THE CITY OF DURHAM TRUST

DM/23/00591/OUT: Outline planning application (with all matters reserved apart from access) for the development of up to 370 dwellings, an extension to Sniperley park and ride, demolition of former farm buildings and associated infrastructure works, land north and east of Sniperley Farm, Durham DH1 5RA

DM/22/03778/FPA: Hybrid planning application consisting of outline planning permission (all matters reserved) for an extension to the Sniperley Park and Ride, and full planning permission for the development of 368 dwellings, associated access and works, and demolition of former farm buildings (resubmission).

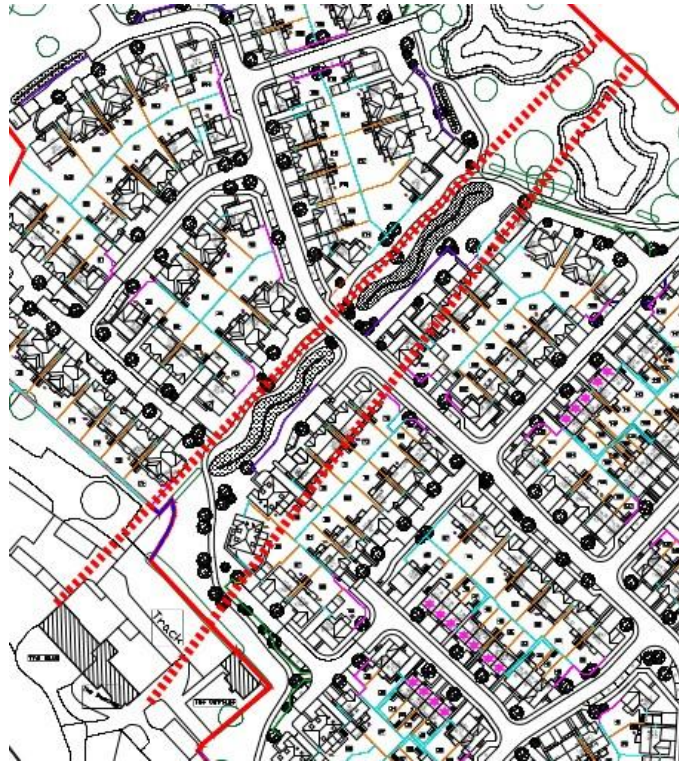
The layout of the housing immediately to the north of the Hall, where eight houses back onto the historic parkland with 1.8m close boarded fences, does not seem to have regard to the character or setting of the Hall. The housing density may be reduced slightly compared to the rest of the development, but only by providing more substantial private gardens. This falls substantially below the design quality expected by the policy.

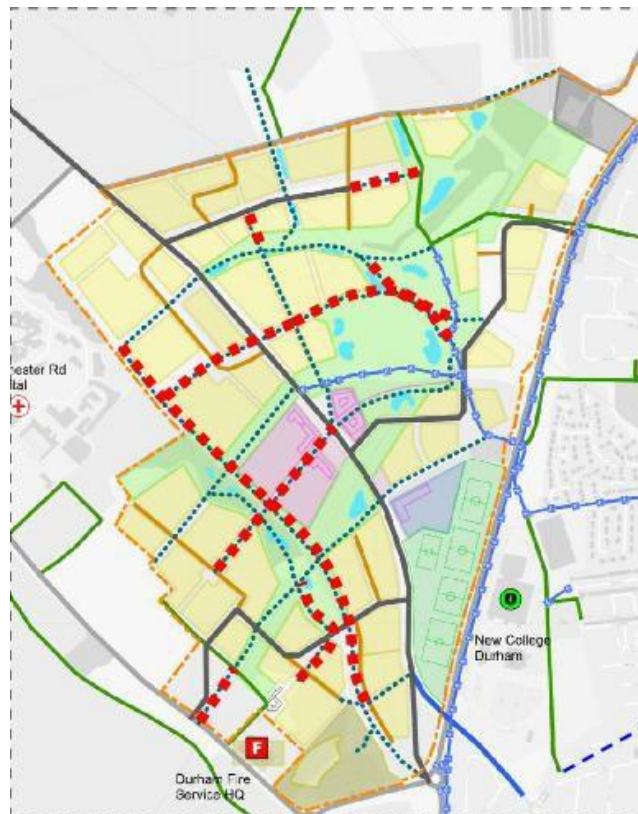
The applicant claims that 42% of houses will be oriented in a southerly direction. Looking at the proposed layouts it is clear that the vast majority of houses are oriented with their corners pointing directly to the compass points, and thus have one of their windowless side walls facing either SW or SE. The main access roads are aligned SE to NW and so many houses will receive no solar gain through windows until the afternoon. This might be an advantage in hot summers, but will not help reduce heating bills. The applicant has not answered the question about the thermal comfort/overheating assessment.

Overall, the Trust considers that the application does not meet the requirement of Policy 29(c) to "minimise greenhouse gas emissions".

Network connectivity

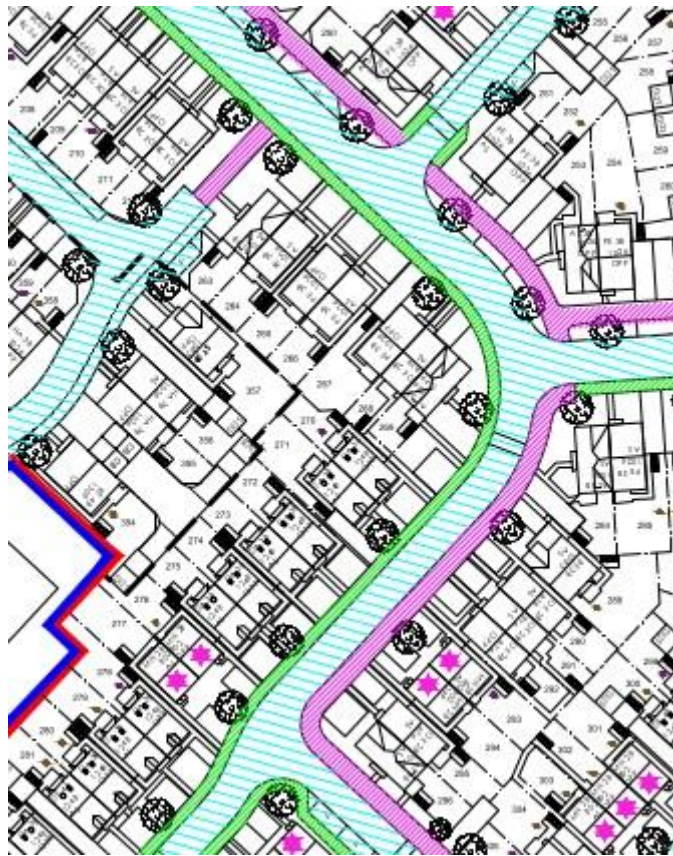
There are various unfortunate inconsistencies in the documentation provided. The Adoptable Highways Plan shows cycleways in pink, footways in green, and footpaths in brown. The Movement Hierarchy Plan uses a different notation, and differs in omitting the off-carriageway cycle link to the Park and Ride. The Proposed Layout Sheet 1 labels the path leading out of the north end of the site “Cycle path connection to adjacent scheme” but on the other two plans this is indicated as pedestrian only. Page 97 of the Design and Access Statement swaps the labelling of the paths, making the north end link the only cycle path. The Transport Assessment, Figure 11, shows a cycle path running NW from the crossing of the main access road along the edge of the site by Sniperley Farm, and ending by the access road to the NW portion of the development. This is not shown as a cycleway on any of the other plans. At 2.0m wide it would not comply with LTN 1/20, and this is perhaps why it has been omitted from the cycle network.

It is quite clear that people are very likely to wish to access a number of these routes by cycling. They should be redesigned to be a minimum of 3.0m wide. In particular the route parallel to the electricity pylons, which will be the shortest route to the primary school, should be upgraded in width. The route from the north end of the site, which is likely to be the shortest route to the local shops on the B6532, should also be upgraded for cycling. A third link, along the alignment of the Masterplan's “Sniperley Hall Street” should also be provided. This will entail redesigning the road layout.

Apartment blocks

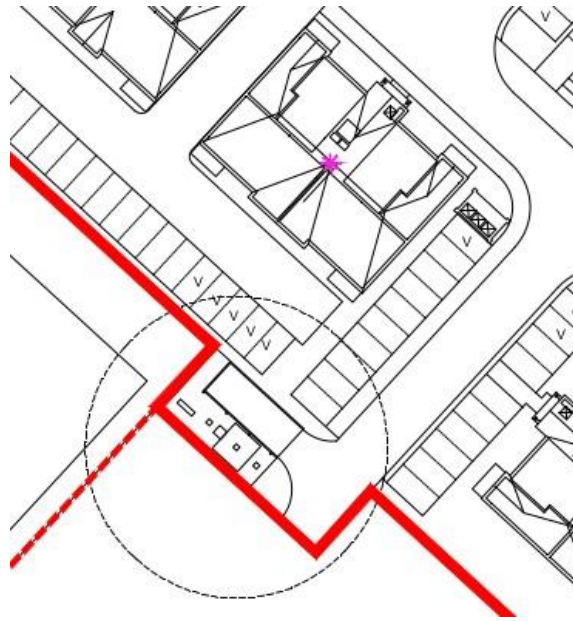
The plans for the Beekeeper and Honeyman apartment blocks do not show any cycle parking on the ground floor of the block. Without proper provision residents may be tempted to use some of the stairwell space on each floor to store bicycles, and this could be a risk during a fire evacuation. On the Proposed Layout drawings there are some rectangles close to the buildings but it is not clear if these are secure cycle parking (e.g. lockable hangars).
